# Access Compliance Report

## Public Rights-of-Way

### (Curb Ramps)

Intersection ID: 15316	Main Street: CARLING_AV	Cross Street: CHARLOTTE_DR	Location: W
ADA ID: 3CAFF1FA940D	Ramp Type: Perp	Initial Pass/Fail: Fail	Overall Compliance: No
		Severity Score: 12.5

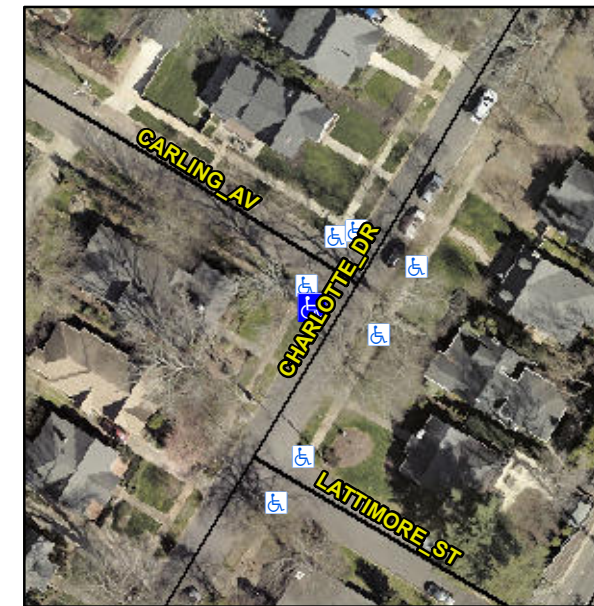
**Not Found, R304.2.2**

Compliance	Description	Data	Compliance	Description	Data
N/A	Ramp Length (in)	74.0	No	Ramp Slope (%)	10.1
Yes	Ramp Width (in)	48.0	Yes	Ramp XSlope (%)	1.6
N/A	Flare Type LT	N/A	N/A	Flare Type RT	N/A
N/A	Flare Slope LT (%)	N/A	N/A	Flare Slope RT (%)	N/A
N/A	Flare Traversable LT?	N/A	N/A	Flare Traversable RT?	N/A
N/A	Landing Length (in)	N/A	N/A	DWS Provided?	N/A
N/A	Landing Width (in)	N/A	N/A	DWS Contrast?	N/A
N/A	Landing Slope (%)	N/A	N/A	DWS Length (in)	N/A
N/A	Landing X Slope (%)	N/A	N/A	DWS Full Width?	N/A
N/A	Landing Curb? (Y/N)	N/A	N/A	DWS Offset (in)	N/A
N/A	Shared Landing?	N/A			
N/A	Gutter Ponding?	N/A	N/A	Gutter Slope (%)	N/A
N/A	Gutter Lip Ht (in)	N/A	N/A	Gutter X Slope (%)	N/A
N/A	Painted X Walk1?	No	N/A	Painted X Walk2?	N/A
	X Walk 1 Direction	To SE		X Walk 2 Direction	N/A
N/A	X Walk 1 Width (in)	N/A	N/A	X Walk 2 Width (in)	N/A
	X Walk 1 Slope (%)	3.8		X Walk 2 Slope (%)	N/A
	X Walk 1 X Slope (%)	1.1		X Walk 2 X Slope (%)	N/A

**Remove & Replace Entire Ramp.**
